VAPOR INTRUSION SCOPING MEETING SUMMARY

MAIN INSTALLATION, DEFENSE DEPOT MEMPHIS, TENNESSEE

12 February 2020, 8:30 AM EDT

Figure 11

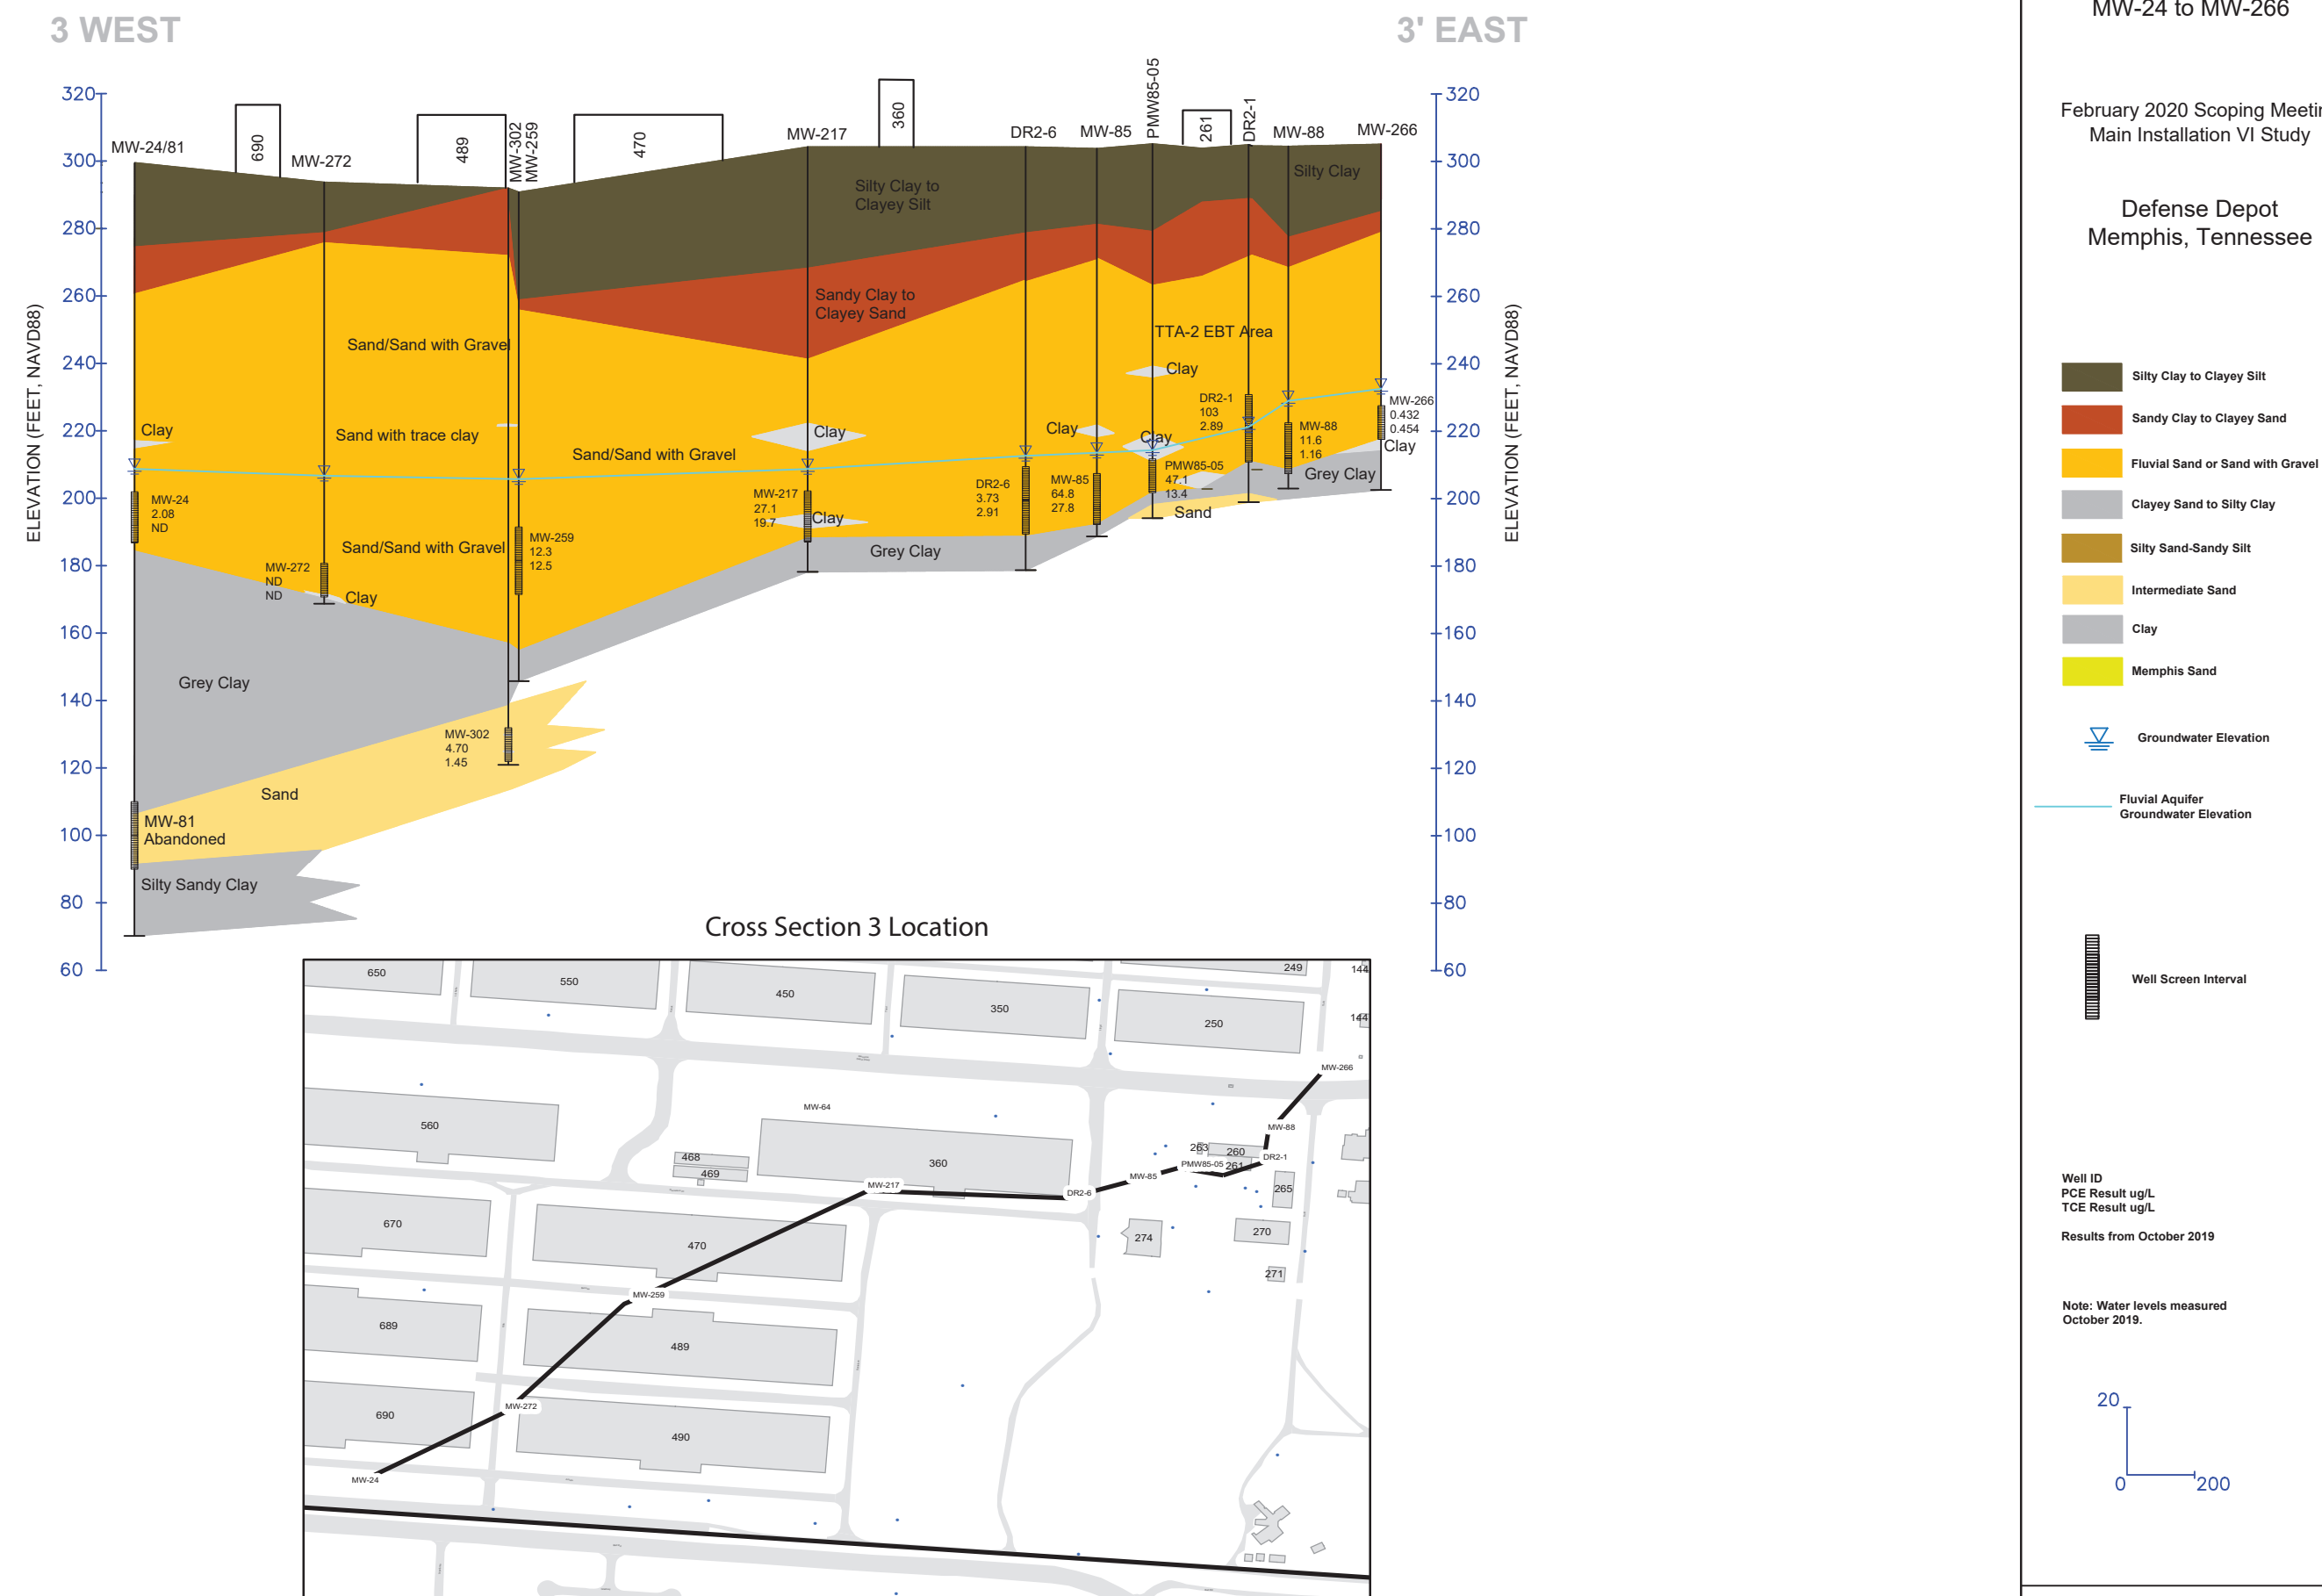
The location of the SVE pilot test and screen depths of the VMPs and the SVE well at TTA-2 was discussed during review of [Figure 11](#). Mr. Holmes discussed the general CSM for groundwater impacts at DDMT. Spills/releases of VOCs to the ground are retained in the fine-grained soil near the surface and slowly migrate vertically into the deeper coarse-grained sand and gravel, and then to groundwater. The SVE well interrupts the migration through the coarse-grained deposits within its zone of influence preventing further impacts to groundwater while the system operates. Ms. Lloyd stated the SVE system should also increase the migration from the fine-grained deposits.
